Onondaga County Planning Board

MEETING AGENDA

Wednesday, November 5, 2025

Z-25-333 (from Z-23-298)

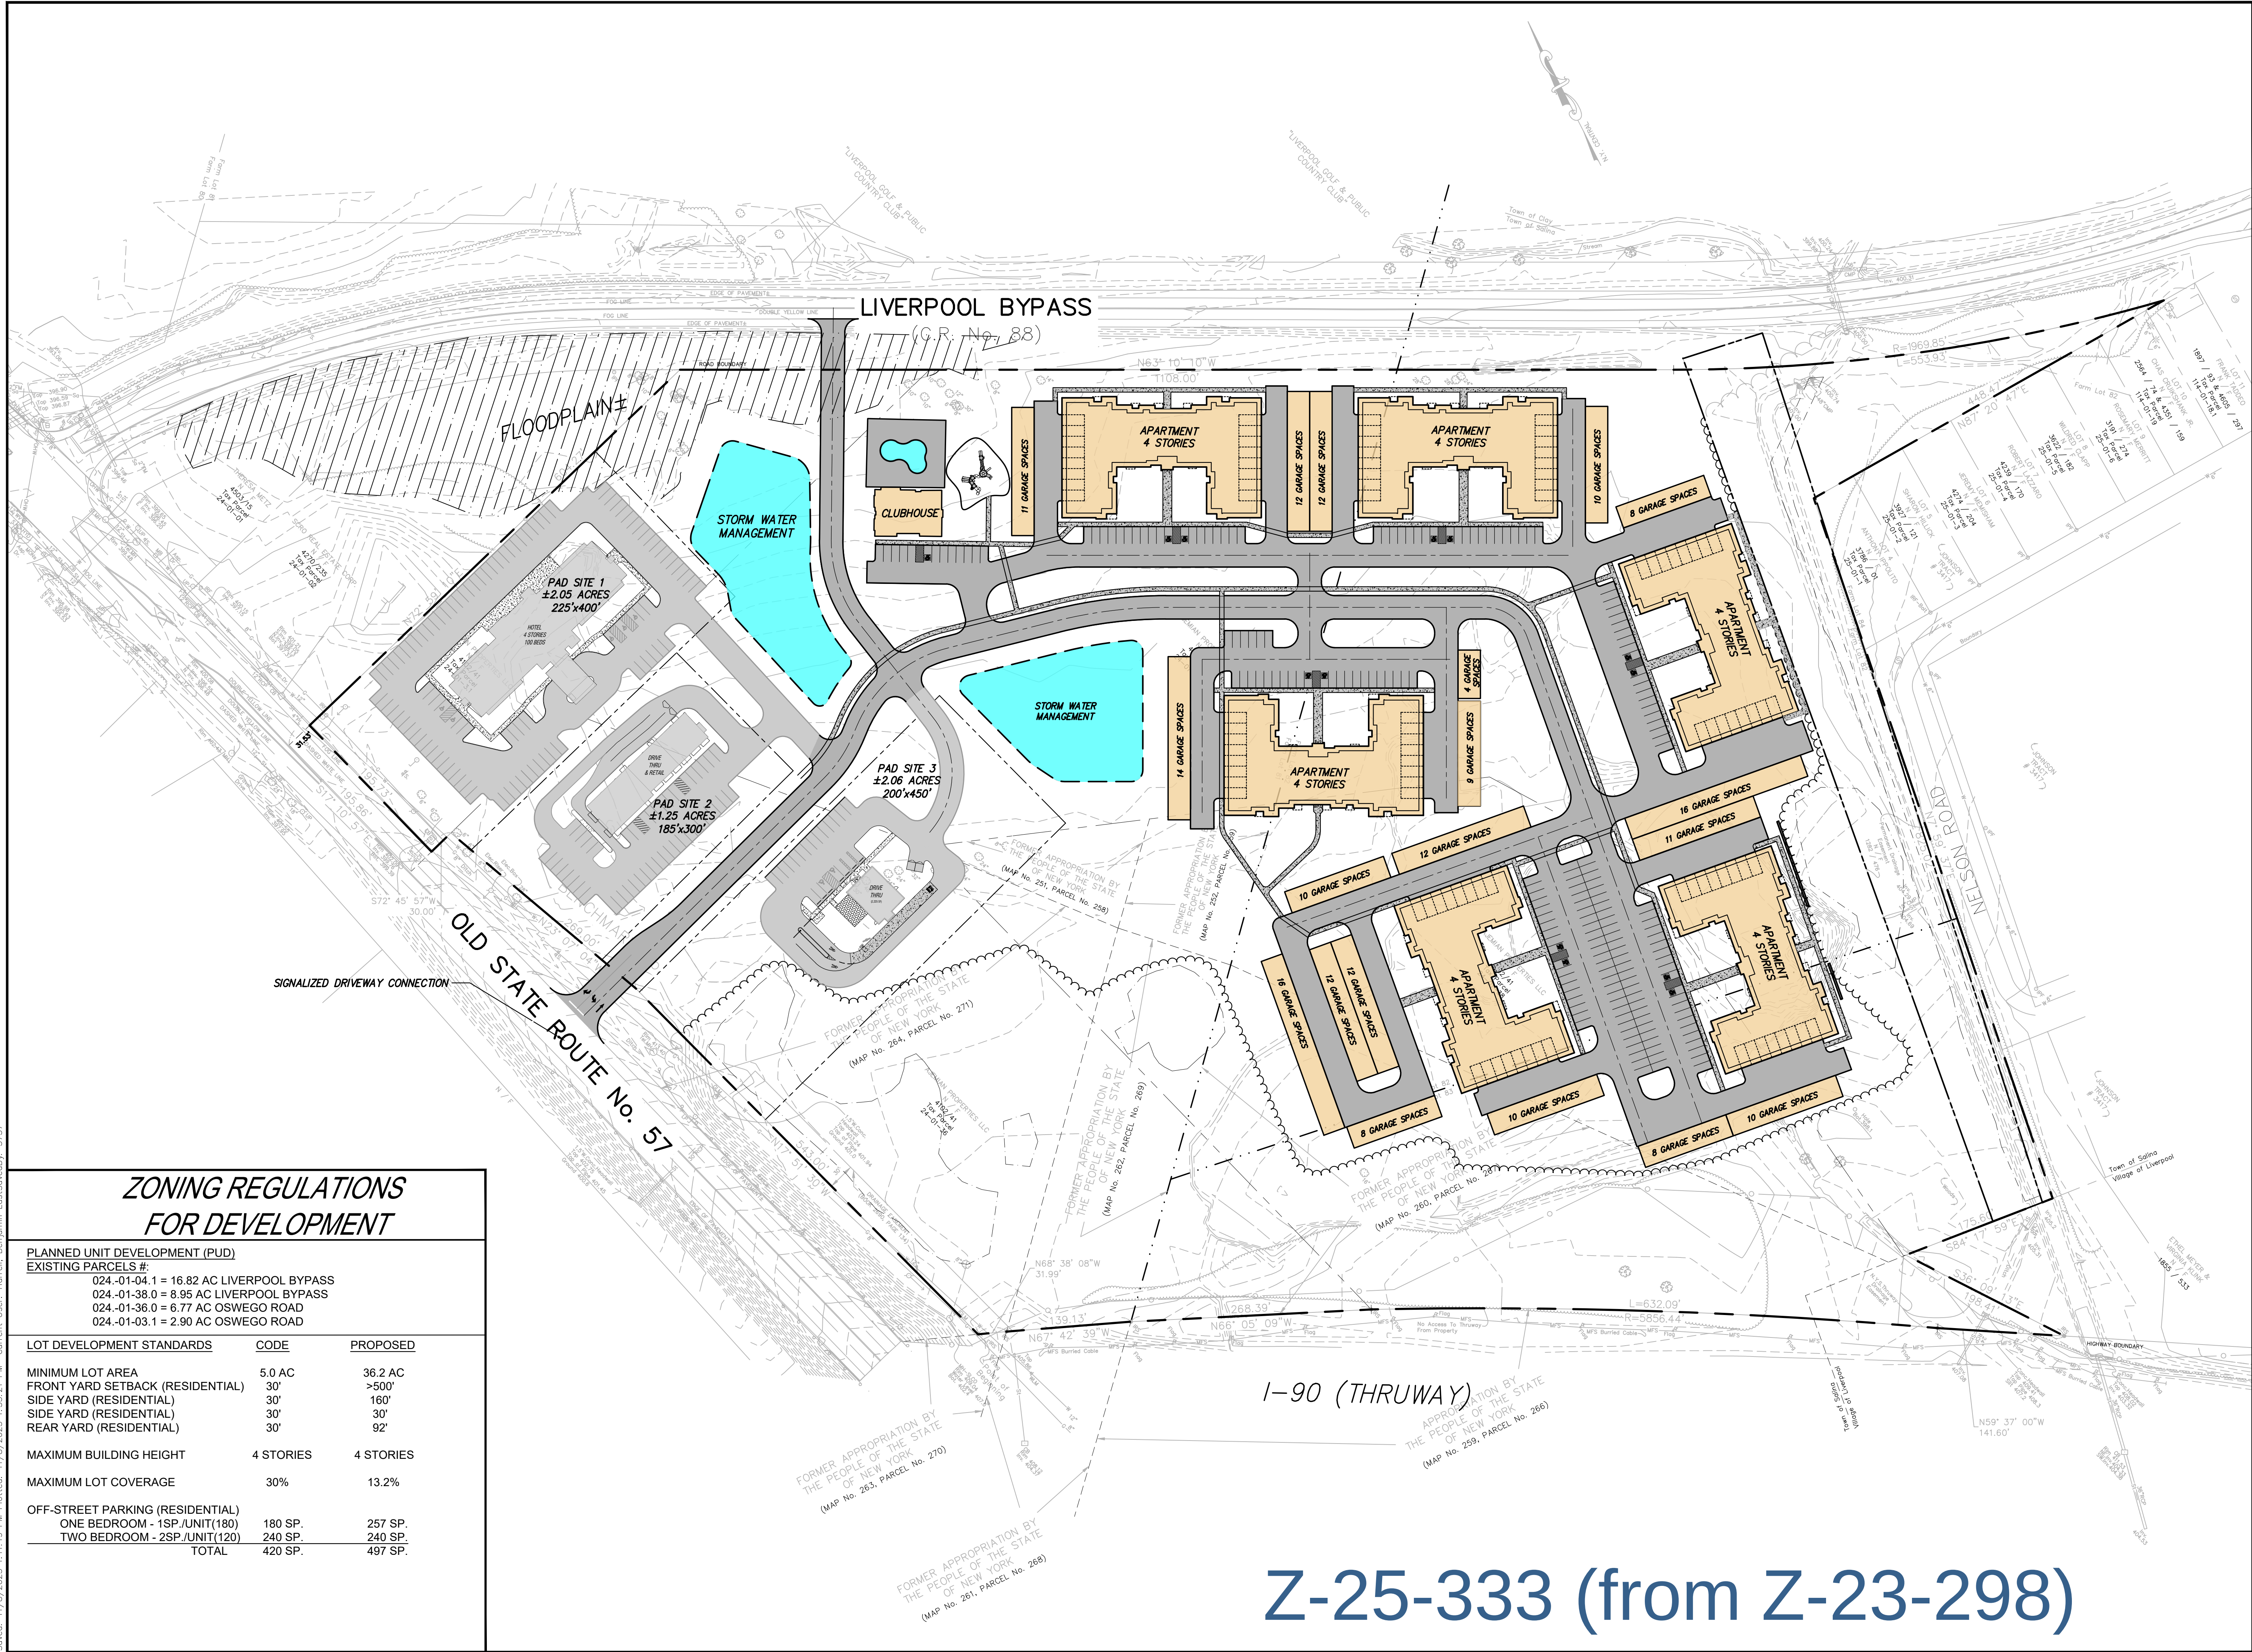
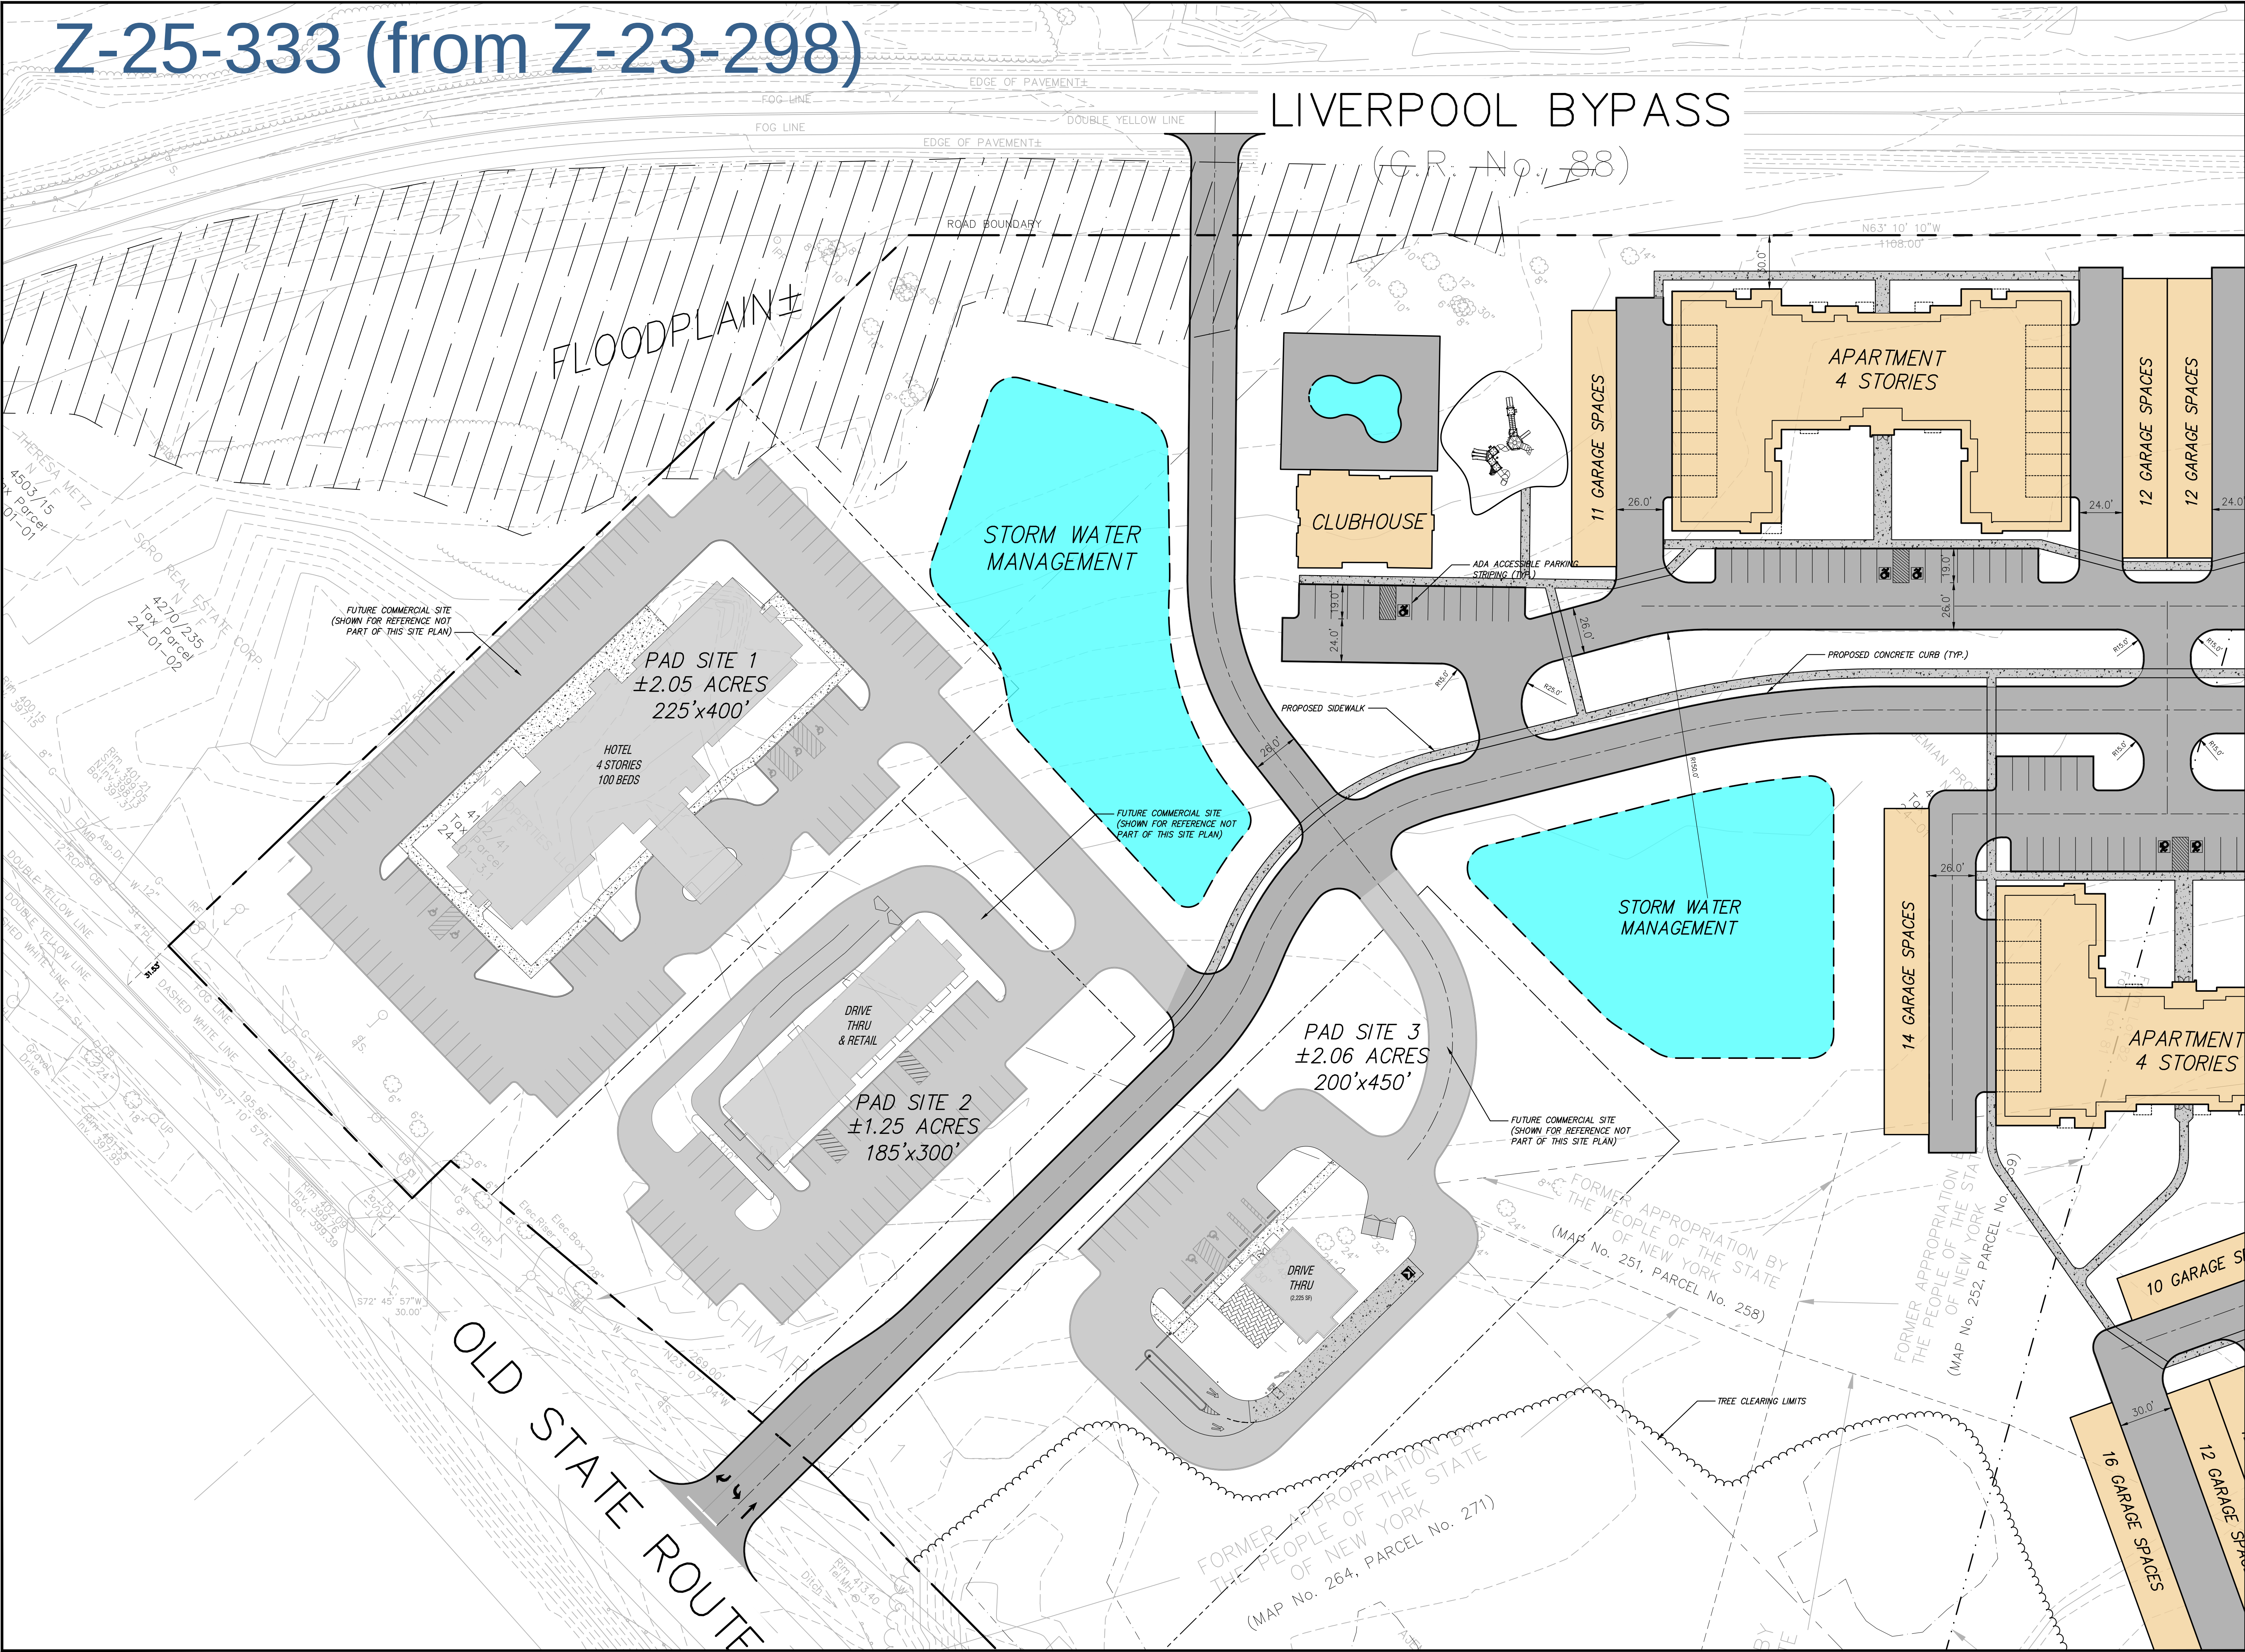
Proposed Site Layout:	The applicant is proposing construction of a gas station and a 6,975 sf building to contain a Circle K market, Jimmy John's, and Wendy's. Per the Site Layout Plan dated 10/9/25, the site will have fuel pumps, air, and vacuum machines along Oswego Road frontage. The building will be constructed behind the pump area with parking with a drive thru lane and bypass lane along the rear of the building. A dumpster enclosure will be located in the rear corner of the asphalt area. Per the Site Layout Plan, 12 spaces along the front of the building and 25 along the rear yard are proposed.

Access: Per the Site Layout Plan, the site will have direct right-in ingress from Oswego Road and full access via an interior road at the rear and northern sides of the site. Access to the site will be provided via a new internal road to be constructed adjacent to the site.

Wetlands: GIS mapping shows approximately 4.7 acres of the PUD site may contain federal and/or NYS wetlands. It is not clear if the wetlands extend to the current subject area and wetlands are not depicted in the currently referred plans.

Stormwater: Per the Environmental Assessment Form (EAF) dated 10/10/25, 1.65 acres of the site will be disturbed by the proposed project. Per the EAF, "stormwater management for the site has been included in the overall PUD development. A SWPPP has been prepared and an eNOI has been submitted for coverage under GP-O-25-001 (SPDES Permit ID NYR11P316)." The Stormwater Pollution Prevention Plan (SWPPP) and/or copy of the SPDES Permit were not included in the referral materials. Per the Site Layout Plan, multiple stormwater management areas are depicted on the PUD site surrounding the subject area, but none are depicted in the subject area.
